Technical Bulletin 56

BMFL Beam Exposure Protection

This bulletin describes additional techniques to prevent externally caused damage to the BMFL internal parts.

3. Software update to enable Home position

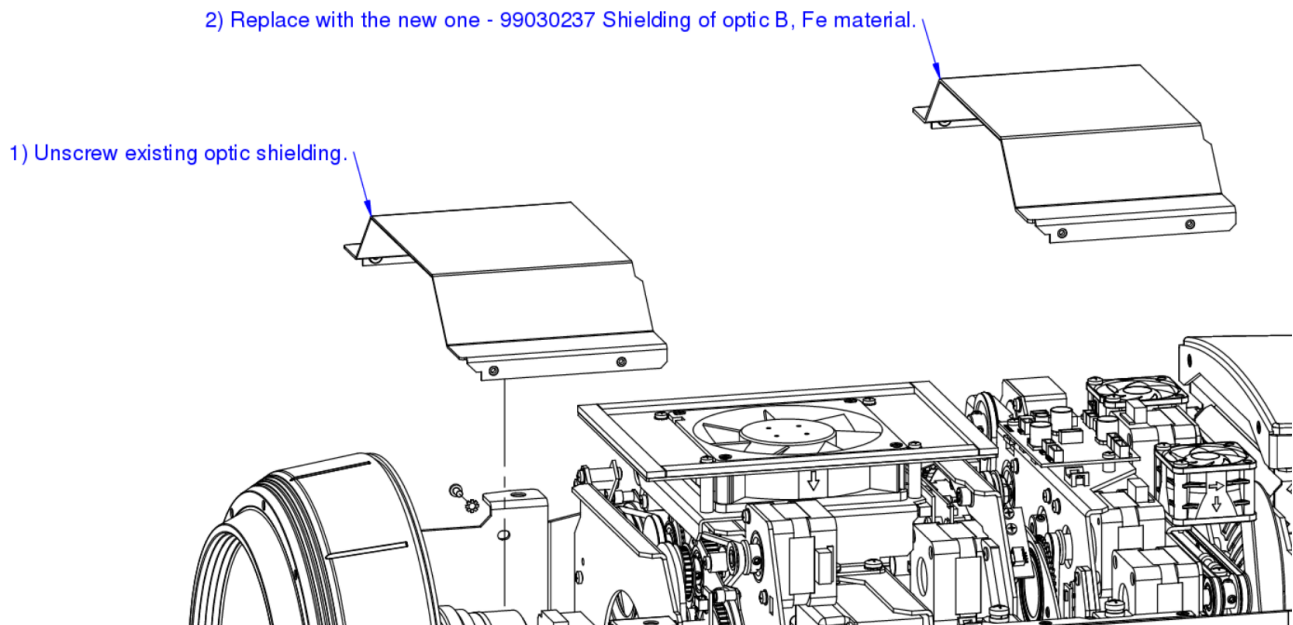
Home position setting was introduced in the following versions of software update, older units need to have software updated to get these features.

Fixture	DSU version	Display version	Standard since serial
BMFL Spot	16110742	V3.8/DS	1600553297
BMFL Blade	16110751	V2.2/DS	1600551875
BMFL Wash	16110758	V1.5/DS	1600559733
BMFL WashBeam	16110438	V1.6/DS	1700504852
BMFL WashBeam EV	16110743	V1.3/DS	1600557211
